SERVICE LETTER

No. 543

Subject: Induction System Drain Tube Relocation

Models Affected: PA-24-260 Comanche "C"

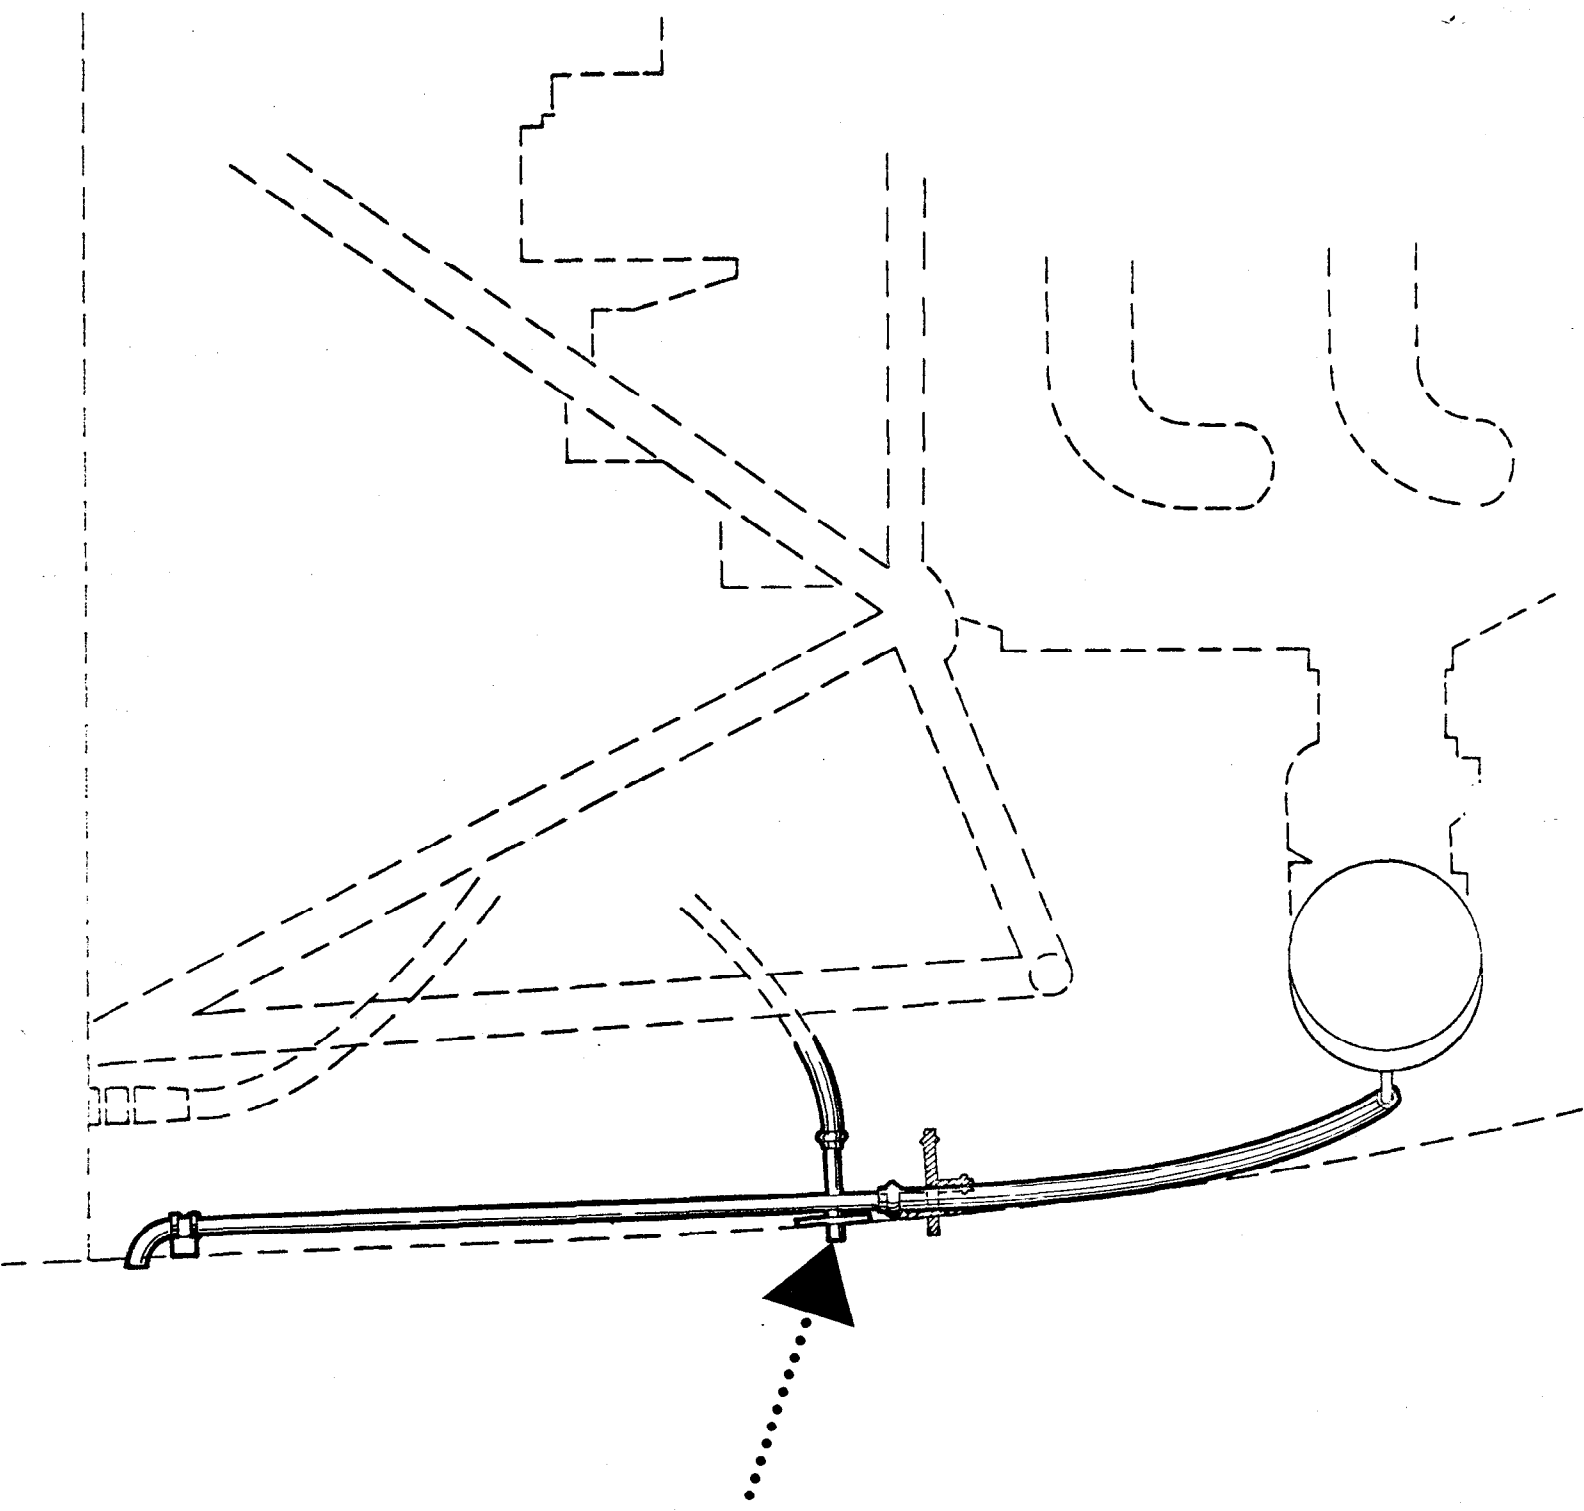
Purpose: To provide material and instructions for the relocation of the induction system drain tube in the engine cowling. This modification will provide increased clearance between the drain tube and the exhaust system (see sketch on reverse side of this letter for general information).

Instructions: Contained in Kit No. 760 351, Induction System Drain Tube Relocation.
